CONTRACT
PIZZA EXPRESS
30 COPTIC STREET
LONDON
WC1A 1NS

PROPOSED EXTERNAL SEATING

SCALE: 1:50 & 1:2500
 DATE: 26/01/06
 DRAWN: B.D./ AutoCAD 2005
 DRAWING No 5045/15_01
 REV

SITE PLAN 1:50

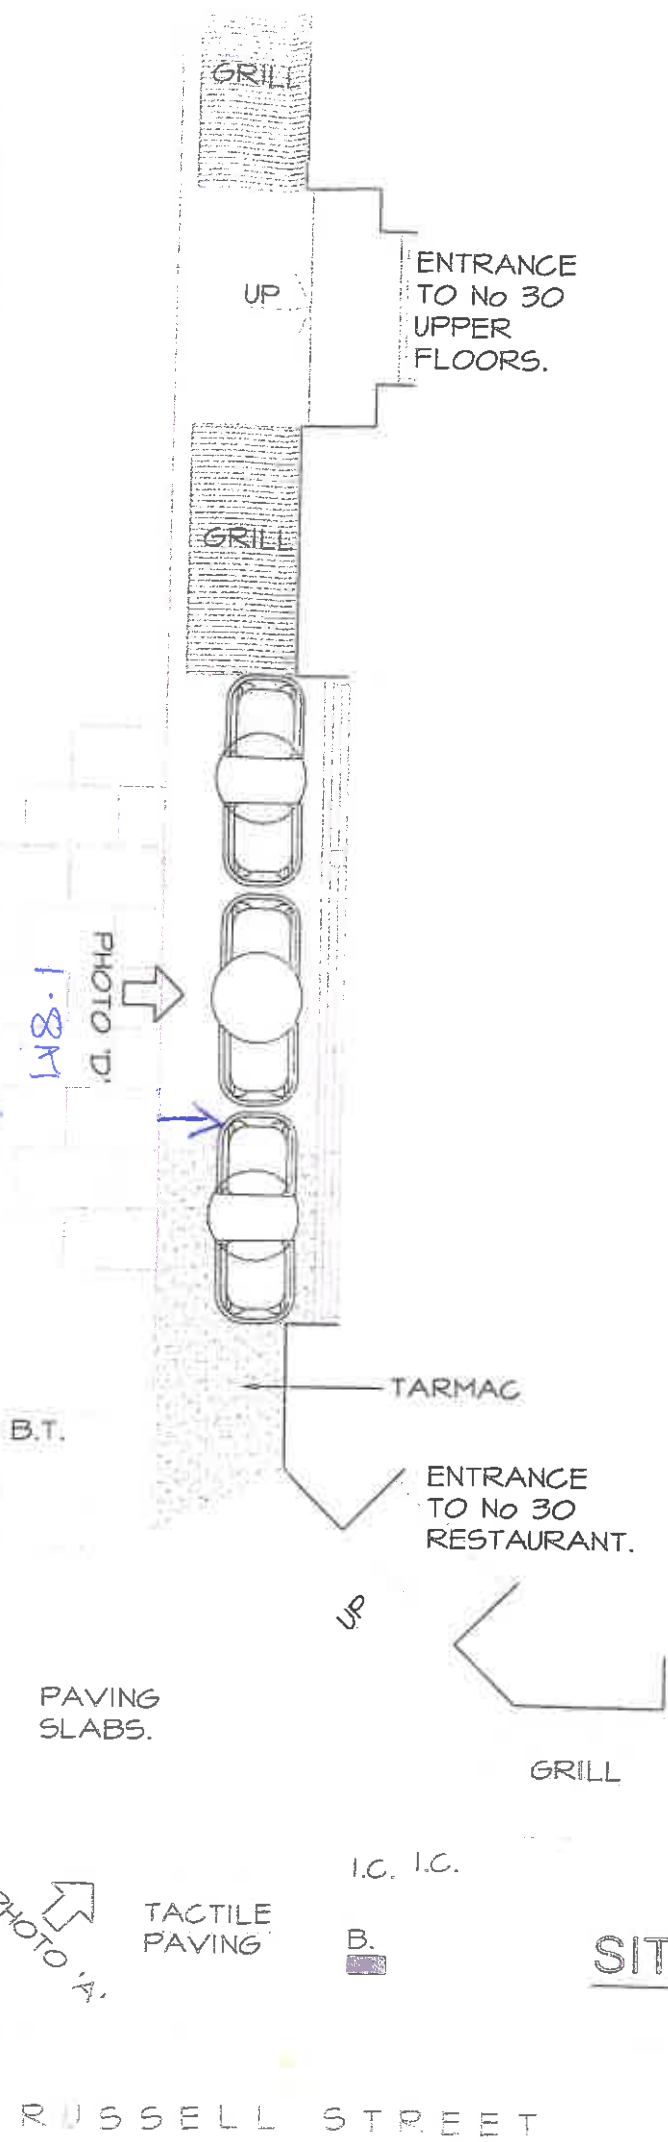
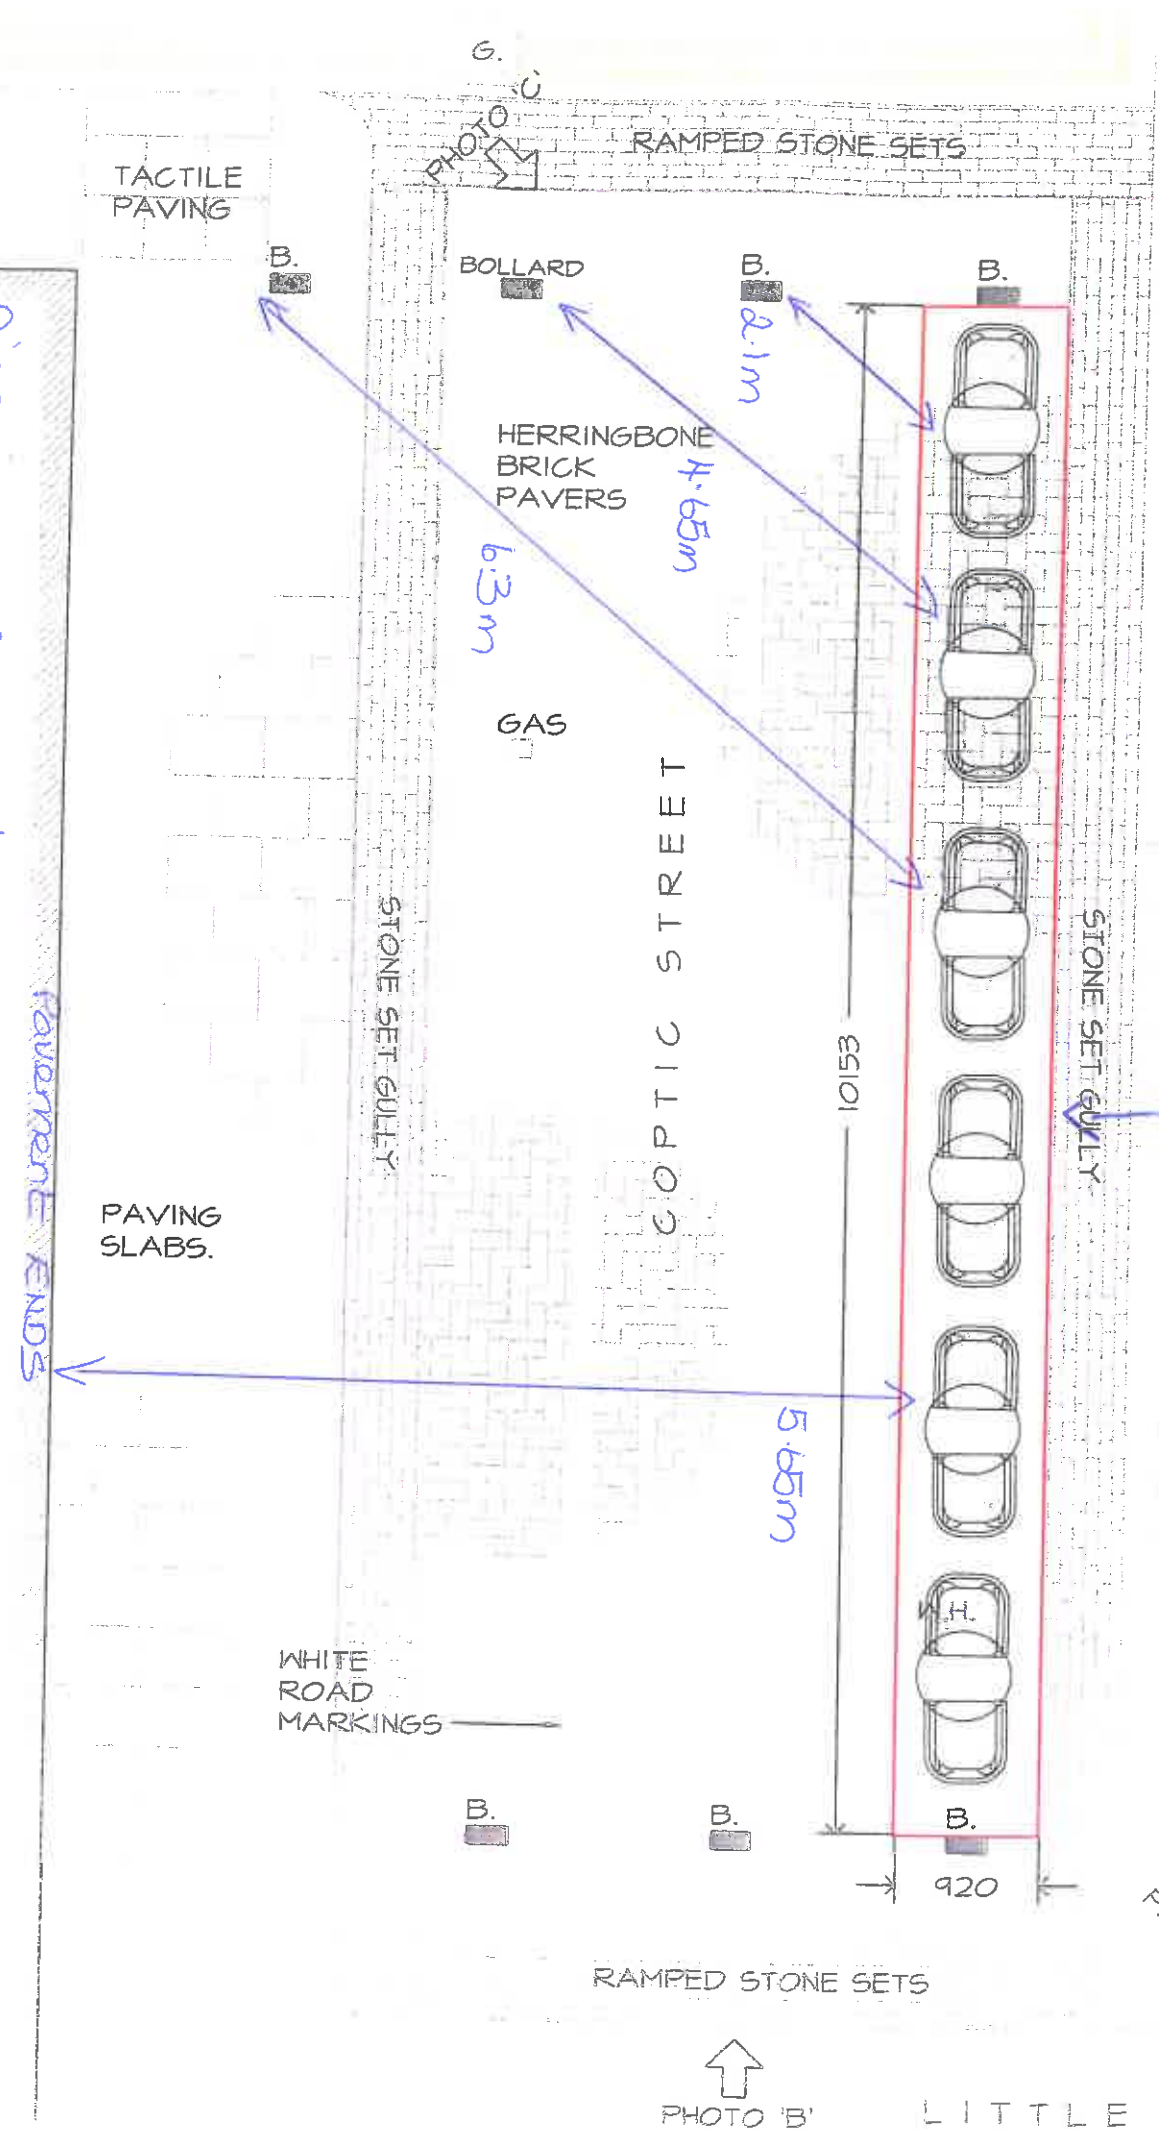
Dimensions of table and chairs is required

Table measurements: 70 x 70cm
 Chair measurements: 45 x 45cm
